# Access Audit Site Report

**Davis Mountains State Park/Complex**

**Accessibility Evaluation**

**Inspection Date: 09/23/2021**

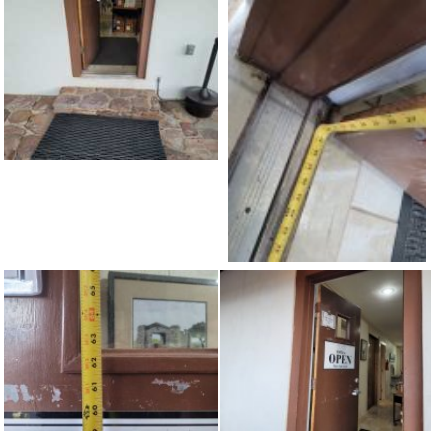
3	Davis Mountains Headquarters: DM Headquarters	[30.5990513, -103.9295527]	The cross slopes (narrow dimension) and/or running slopes (long dimension) of the access aisle exceeds 2%. The running slope and the cross slope in an accessible parking stall and the access aisle must not exceed 2%.	Slope of 3.1% in access aisle (uneven surface)	Repair or correct slope of parking space and access aisle to max 2.08% in any direction	2015 ABAAS Section: 502.4  2012 TAS Section: 502.4  2010 ADAS Section: 502.4

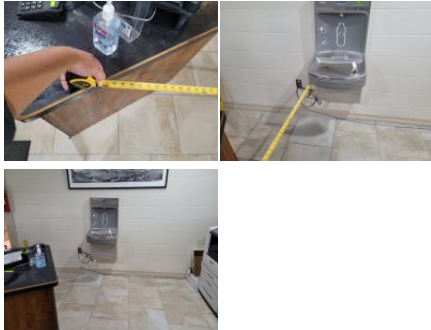
6	Davis Mountains Headquarters: DM Headquarters	[30.5990028 , -103.9295 312]	The ramp on the accessible route contains cross slopes greater than 2%. Surface cross slopes shall not exceed one unit vertical in 48 units horizontal (2-percent slope).	Entry ramp - cross slope of 2.5%	Correct ramp cross slope to max 2.08%.	2015 ABAAS Section: 405.3  2012 TAS Section: 405.3  2010 ADAS Section: 405.3

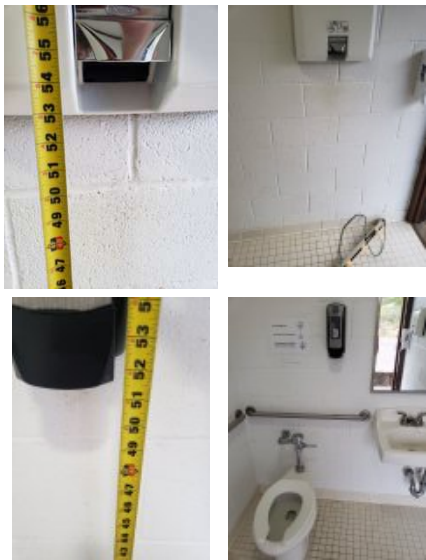
Finding Number	Area Description	Lat/Long	Finding	As Built	Recommendation	Citation	Photos	Figure
10	Davis Mountains Headquarters: DM Headquarters	[30.5991242, -103.9294443]	Minimum maneuvering clearances at doors and gates shall comply with 404.2.4. Maneuvering clearances shall extend the full width of the doorway and the required latch side or hinge side clearance. Maneuvering clearances shall have a max slope of 2.08%.	Entry side door - slope of 2.3% in clearance on push side	For all doors along the public circulation route, provide required maneuvering clearance on push and pull side of doors. For all doors along the public circulation route, correct slope in door clearance to max 2.08%.	<p>2015 ABAAS Section: 302.1, 302.2, 302.3, 302.1 EXCEPTION S: 1, 404.2.4.4, 404.2.4.4 EX CEPTIONS: 1, 404.2.4.4 E XCEPTIONS: 2</p> <p>2012 TAS Section: 302.1, 302.1 Exception 1, 302.3, 404.2.4.4, 404.2.4.4 Exception 1, 404.2.4.4 Exception 2, 302.2</p> <p>2010 ADAS Section: 302.3, 302.1, 302.2, 404.2.4.4</p>

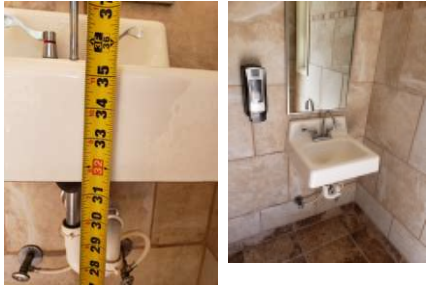
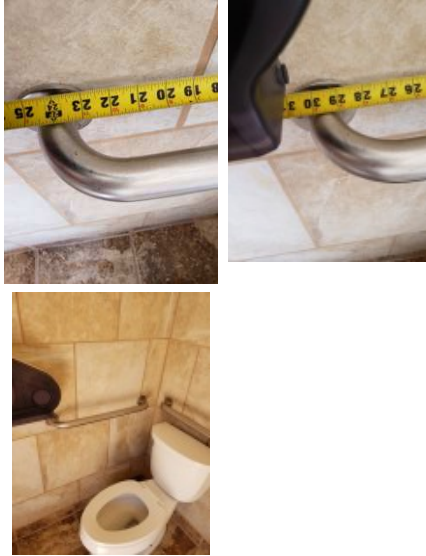
117	Davis Mountains Campsites 46-61: DM Campsites 46-61 Men's Restroom	[30.5977273, -103.9282545]	The top rim of the sink is too high. All lavatories/sinks that are designated to be accessible shall be a minimum 17 inches in horizontal depth and mounted with the rim or counter edge no higher than 34 inches above the finished floor.	The top rim of the sink is 34.5" aff	Lower sinks to max 34" aff to front of rim. In the alternative, leave as is citing construction tolerance.	2015 ABAAS Section: 606.3 2012 TAS Section: 606.3 2010 ADAS Section: 606.3

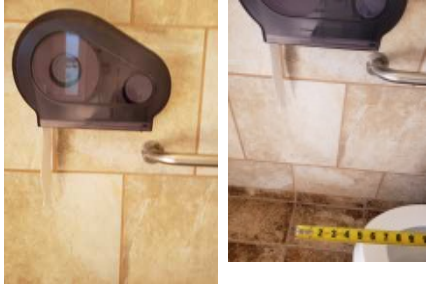
121	Davis Mountains Campsites 46-61: DM Campsites 46-61 Men's Restroom	[30.5977284, -103.9282505]	The toilet paper is not installed within the compliant range in front of the toilet. Toilet paper dispensers shall be 7 inches minimum and 9 inches maximum in front of the water closet measured to the centerline of the dispenser. The outlet of the dispenser shall be 15 inches minimum and 48 inches maximum above the finish floor and shall not be located behind grab bars. Dispensers shall not be of a type that controls delivery or that does not allow continuous paper flow. There shall be a clearance of 1 1/2 inches minimum below the grab bar.	Centerline of toilet paper dispenser is 4" from front of toilet	Remount toilet paper dispenser max 7" to 9" from front of toilet, 15" to 48" aff and min 12" above or 1.5" below grab bar.	2015 ABAAS Section: 604.7 2012 TAS Section: 604.7 2010 ADAS Section: 604.7

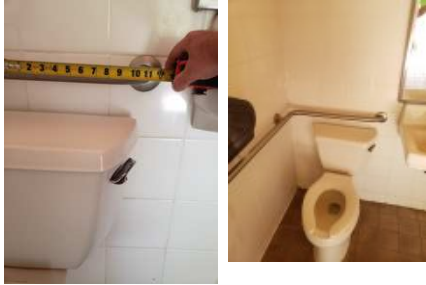
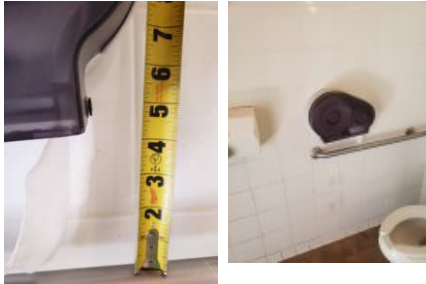
Finding Number	Area Description	Lat/Long	Finding	As Built	Recommendation	Citation	Photos	Figure
146	Davis Mountains Campsites 17-27: DM Campsites 17-27 Men's Restroom	[30.5953942, -103.9323328]	Minimum maneuvering clearances at doors and gates shall comply with 404.2.4. Maneuvering clearances shall extend the full width of the doorway and the required latch side or hinge side clearance. The sweep period for doors with closers shall be adjusted so that from an open position of 70 degrees, the door will take at least 3 seconds to move to a point 3 inches from the latch, measured to the leading edge of the door. Exterior doors are recommended to be maintained at 8.5 lbf as a smart practice. Force is to be measured at the operating hardware or 30 inches from the hinges, whichever is greater. Doors, gates, and side lights adjacent to doors or gates, containing one or more glazing panels that permit viewing through the panels shall have the bottom of at least one glazed panel located 43 inches (1090 mm) maximum above the finish floor. EXCEPTION: Vision lights with the lowest part more than 66 inches (1675 mm) from the finish floor or ground shall not be required to comply with 404.2.11.	Accessible restroom door - 14" to wall on pull side clearance, 18# push, fast close, vision panel at 50" AFF	For all doors along the public circulation route, provide required maneuvering clearance on push and pull side of doors For all doors along the public circulation route, inspect, adjust, and maintain closing speed on door closers For all doors along the public circulation route, inspect, adjust, and maintain 8.5 lbf to open exterior doors as a smart practice For all doors along the public circulation route, replace doors with ones having sidelight viewing windows max 43" aff	2010 ADAS Section: 404.2.3, 404.2.7, 404.2.4, 404.2.11, 404.2.11 Exception

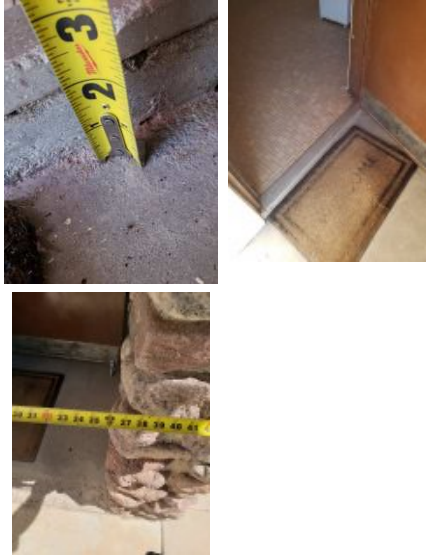
148	Davis Mountains Campsites 17-27: DM Campsites 17-27 Men's Restroom	[30.5954173, -103.9323542]	Transfer type shower compartments shall be 36 inches (915 mm) by 36 inches (915 mm) clear inside dimensions measured at the center points of opposing sides and shall have a 36 inch (915 mm) wide minimum entry on the face of the shower compartment. Clearance of 36 inches (915 mm) wide minimum by 48 inches (1220 mm) long minimum measured from the control wall shall be provided.	dimensions in transfer shower 35.5" wide	Enlarge transfer shower to compliant 36" by 36" clear inside dimension.	2015 ABAAS Section: 608.2.1  2012 TAS Section: 608.2.1  2010 ADAS Section: 608.2.1

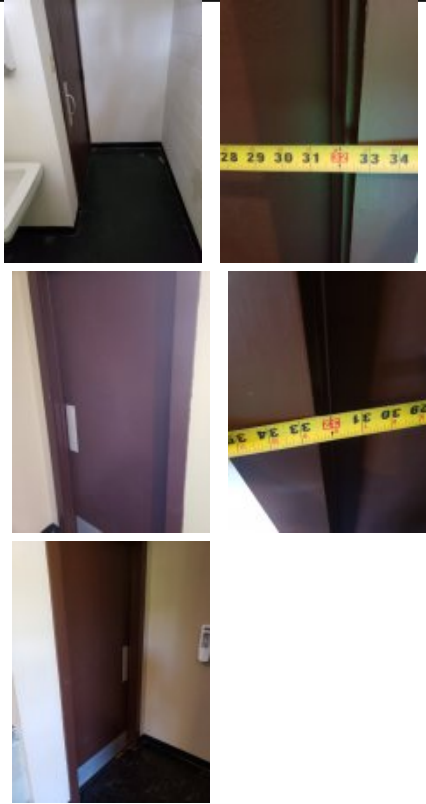
237	Davis Mountains Interpretive Center: DM Interpretive Center	[30.5955212, -103.9304204]	The route of travel at this location does not provide a minimum width of 36 inches. The clear width shall be permitted to be reduced to 32 inches minimum for a length of 24 inches maximum provided that reduced width segments are separated by segments that are 48 inches long minimum and 36 inches wide minimum.	Lacks 36" wide route of travel (chair location narrows route to 30")	Relocate chairs/obstacles to widen AR to compliant 36" clear width.	2015 ABAAS Section: 403.5.1 2012 TAS Section: 403.5.1 2010 ADAS Section: 403.5.1

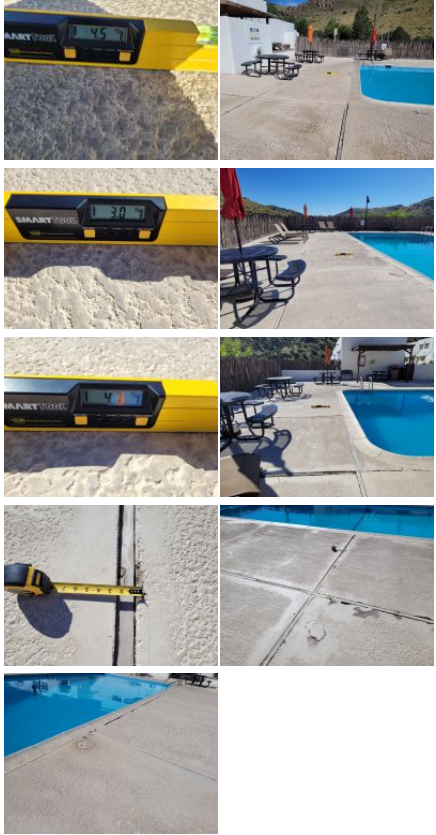
273	Indian Lodge State Park: IL Exterior Accessible Route	[30.59333, -103.944]	The grate openings are greater than 1/2 inch and are parallel to the direction of travel. Openings in floor or ground surfaces shall not allow passage of a sphere more than 1/2 inch diameter. Elongated openings shall be placed so that the long dimension is perpendicular to the dominant direction of travel.	Grate has gaps .75" wide with long dimension in direction of travel	Replace grate with one having openings max .5" and long dimension perpendicular to the path of travel.	2015 ABAAS Section: 302.3  2012 TAS Section: 302.3  2010 ADAS Section: 302.3

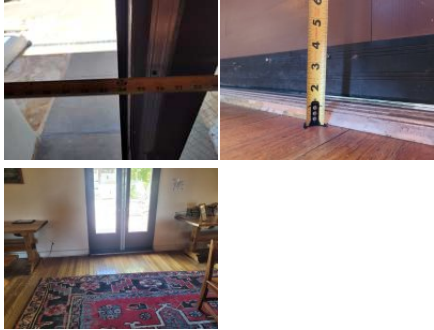
293	Indian Lodge State Park: IL Lodge Public Rooms	[30.5926627 , -103.9435 542]	Minimum maneuvering clearances at doors and gates shall comply with 404.2.4. Maneuvering clearances shall extend the full width of the doorway and the required latch side or hinge side clearance. Maneuvering clearances shall have a max slope of 2.08%. The sweep period for doors with closers shall be adjusted so that from an open position of 70 degrees, the door will take at least 3 seconds to move to a point 3 inches from the latch, measured to the leading edge of the door. Exterior doors are recommended to be maintained at 8.5 lbf as a smart practice. Force is to be measured at the operating hardware or 30 inches from the hinges, whichever is greater.	Assembly room front door - slope of 3.3% on pull side , 12# push, fast close Assembly room rear door - 11# push	For all doors along the public circulation route, provide required maneuvering clearance on push and pull side of doors. For all doors along the public circulation route, correct slope in door clearance to max 2.08%. For all doors along the public circulation route, inspect, adjust, and maintain closing speed on door closers. For all doors along the public circulation route, inspect, adjust, and maintain 8.5 lbf to open exterior doors as a smart practice.	2010 ADAS Section: 404.2.3, 404.2.7, 404.2.4, 404.2.11, 404.2.11 Exception

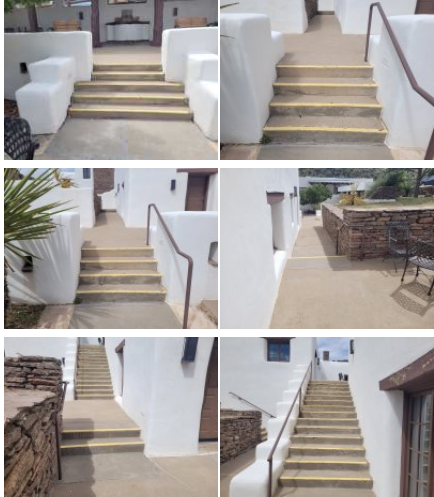
318	Indian Lodge State Park: IL Lodge Public Rooms	[30.5928615 , -103.9435 189]	This stair treads are not stable, firm, and slip resistant.	Historic lobby to upper level - stair treads lack stable, firm, and slip resistant surface (rough stone surface)	Resurface treads with a material that is firm, stable and slip resistant.	2015 ABAAS Section: 302.1, 504.4 2012 TAS Section: 302.1, 504.4 2010 ADAS Section: 302.1, 504.4		
319	Indian Lodge State Park: IL Lodge Public Rooms	[30.5928649 , -103.9435 136]	The stairway treads are sloped greater than 2.08% in any direction.	Historic lobby to upper level - slopes on stair treads due to rough stone surface	Correct or repair slope of tread to max 2.08% in any direction upon tread and riser correction.	2015 ABAAS Section: 504.4 2012 TAS Section: 504.4 2010 ADAS Section: 403.3, 504.4

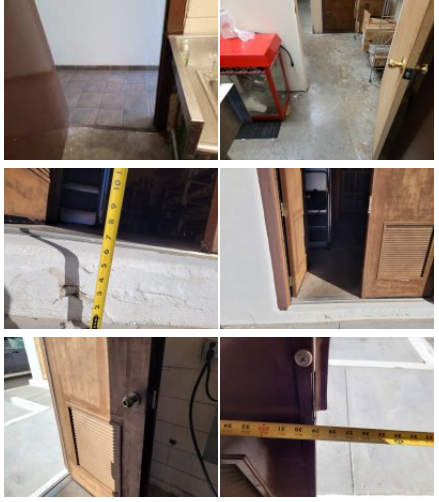
333	Indian Lodge State Park: IL Lodge Public Rooms	[30.5929273, -103.9437 603]	The handrails as well as the handrail extensions are not at the correct height. The tops of handrails and their extensions must be between 34 inches and 38 inches above the stair nosing or ground.	stairs to upper patio and rooms - handrail mounted to 40.5" AGL stairs to upper rooms near Room 112 handrail mounted to 27.5" AGL	Replace or remount handrails to 34" to 38" AFF.	2015 ABAAS Section: 505.4  2012 TAS Section: 505.4  2010 ADAS Section: 505.4		 (a) stairs

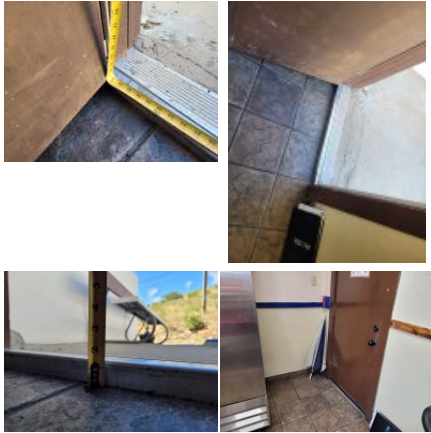
405	Indian Lodge State Park: IL Lodge Room 221	[30.5926338, -103.9433287]	The depth of removable seat is not between the required range. The depth of a removable in-tub seat shall be 15 inches minimum and 16 inches maximum. The seat shall be capable of secure placement.	seat too narrow at 11.5"	Replace tub seat with one that is 15" to 16" deep and capable of being secured.	2015 ABAAS Section: 610.2  2012 TAS Section: 610.2  2010 ADAS Section: 610.2
